Report to	South Downs National Park Authority
Date	6 July 2021
By	Director of Planning
Title of Report Decision	Response to Highways England's Section 42 Statutory Consultation on the M3 Junction 9 Improvements Scheme

Project Title		M3 JUNCTION 9 IMPROVEMENT	
Figure Title		INDICATIVE GENERAL ARRANGEMENT PLAN	
Scale: 1:7,000	Designed: TL	Drawn: TL	Checked: JM
Original Size: A3	Date: 24/05/2021	Date: 24/05/2021	Date: 24/05/2021
Project Ref No: 48176		Revision A

**M3 Junction 9 Improvements Scheme
Statutory Consultation – 27 May to 8 July 2021
Section 42(1)(b) of the Planning Act 2008 and Regulation 13 of the Infrastructure
Planning (Environmental Impact Assessment) Regulations 2017**

Figure Title EXISTING AND NEW WALKING AND CYCLING ROUTES

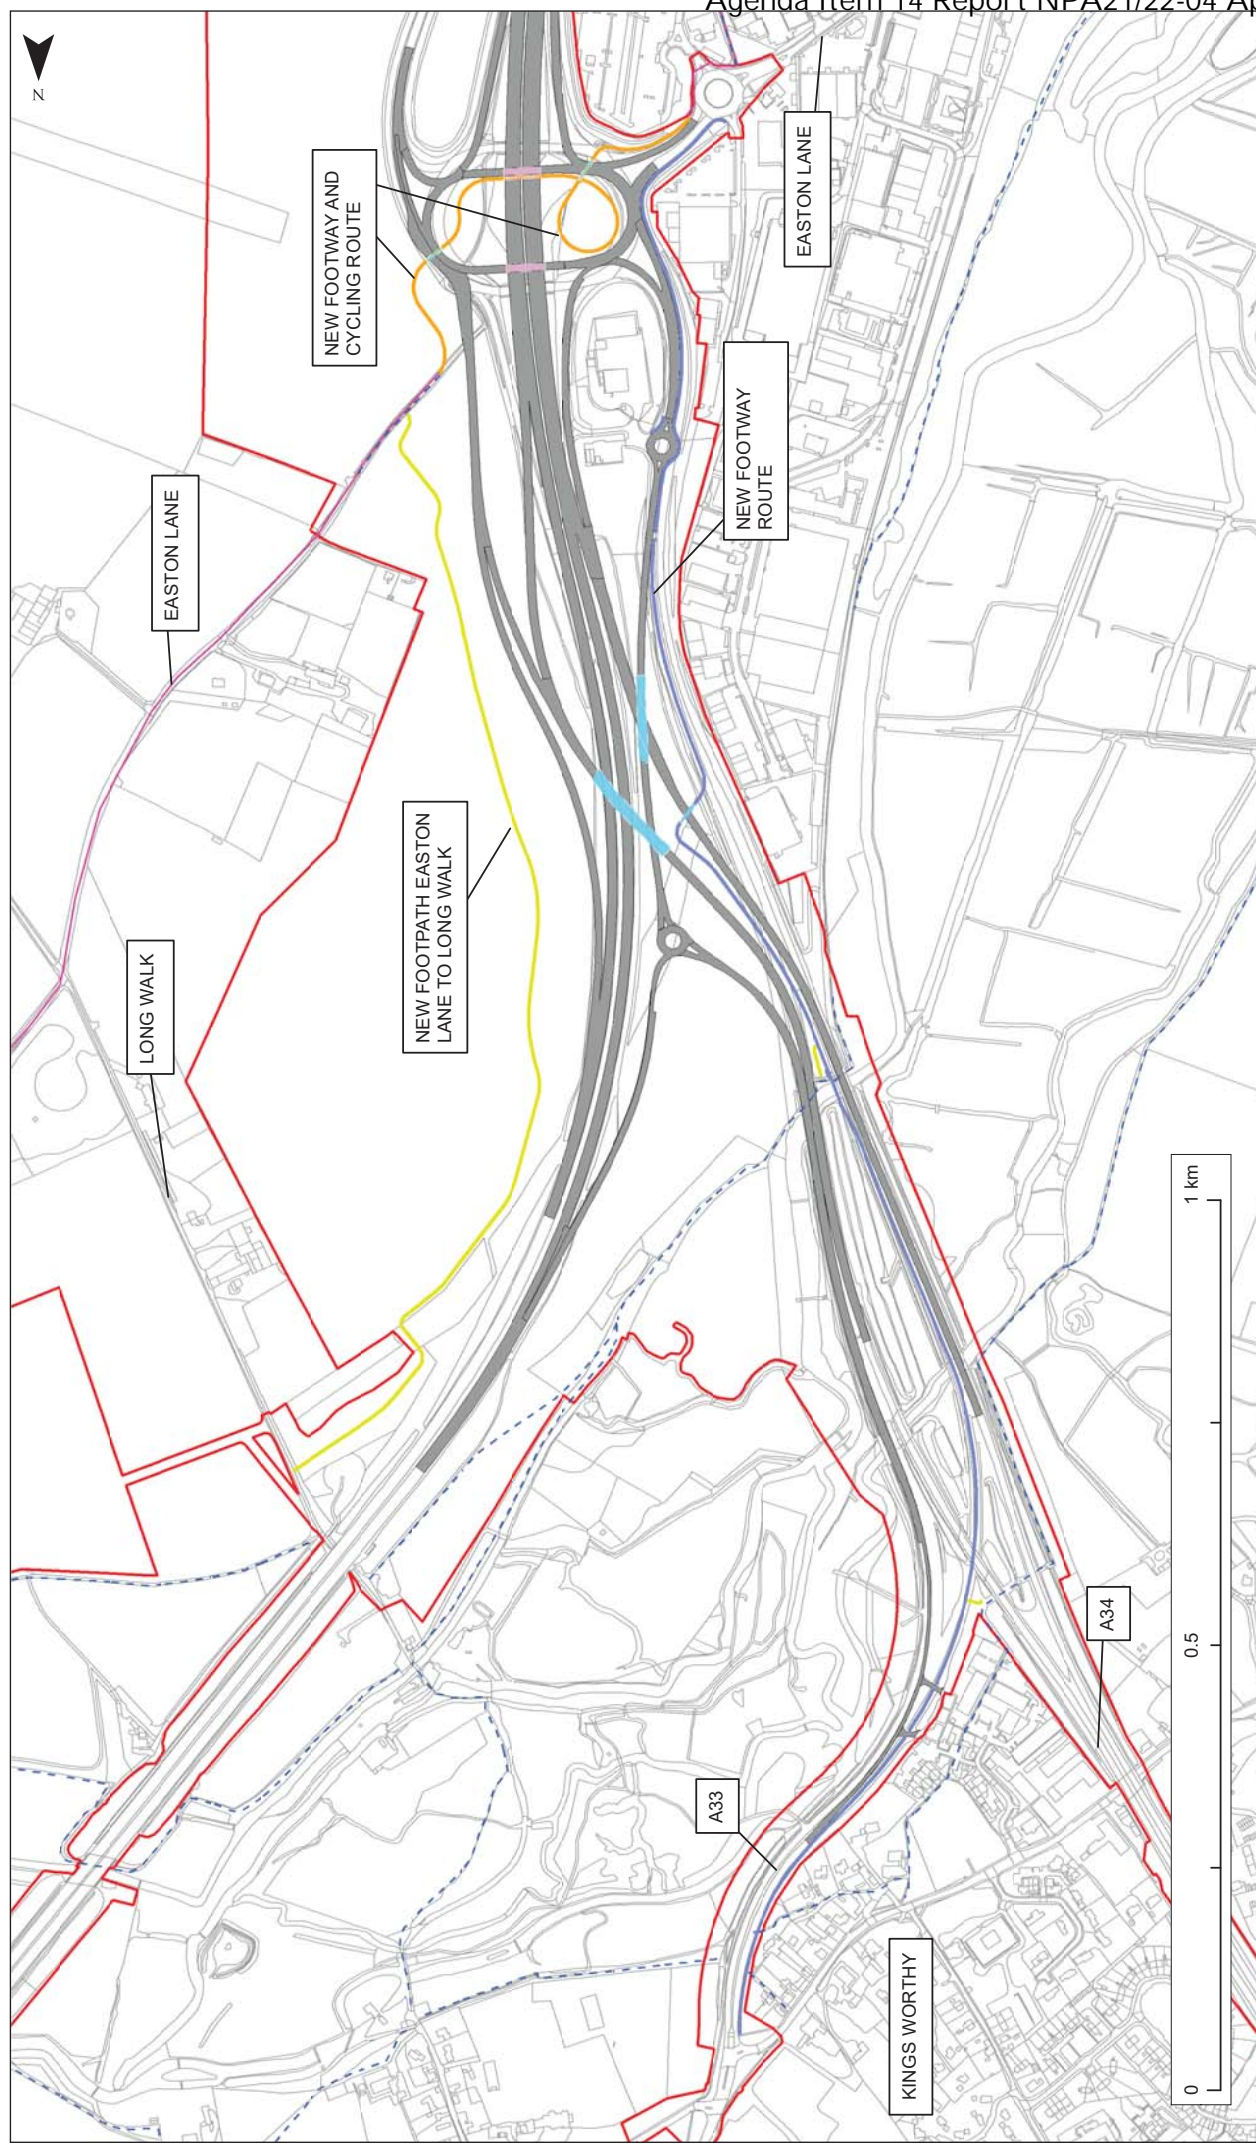
- New Footpaths – it is proposed that the two largest footway improvements (to both the east and west of the Scheme, as highlighted yellow and blue on Figure 2.9) would be for pedestrians only. This would appear to be in direct conflict with the HE's stated strategic objectives for the Scheme to create a 'more accessible and integrated network', the second statutory purpose of a National Park and other national guidance, including from the Department of Transport, which seeks to promote opportunities for active travel modes.

Given that the intention on the western side is to utilise the abandoned carriageways and the route on the eastern is a new route to be constructed, the SDNPA can see no reason why the routes could not be for all users as there would be sufficient width to provide path fit for all to use.

and its inconsistency with current national policy which seeks to ensure transport schemes support increased uptake of active travel modes (for example the Department of Transport publication 'Gear Change: A bold vision for Cycling and Walking and LTN1/20 Cycle Infrastructure Design').
